SERVICE BULLETIN

Classification: EL03-034	Reference: NTB03-087	Date: October 1, 2003
-----------------------------	-------------------------	--------------------------

BOSE® AUDIO SYSTEM – SOUND CLARITY

APPLIED VEHICLE: 2003 350Z (Z33), equipped with Bose® audio system

Figure 1

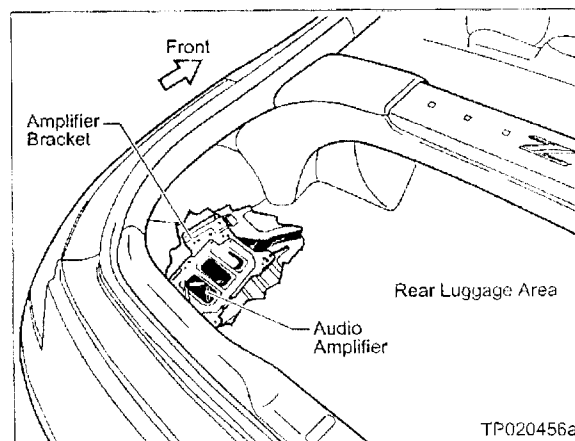
Check the part number on the Audio Amplifier. Refer to the **Audio Amplifier Part Number Check Procedure** (page 2).

- If the part number is **28060-CE400**, this bulletin does NOT apply.
- If the part number is **NOT 28060-CE400**, replace the Audio Amplifier. Refer to the **Audio Amplifier Replacement Procedure** (page 9).
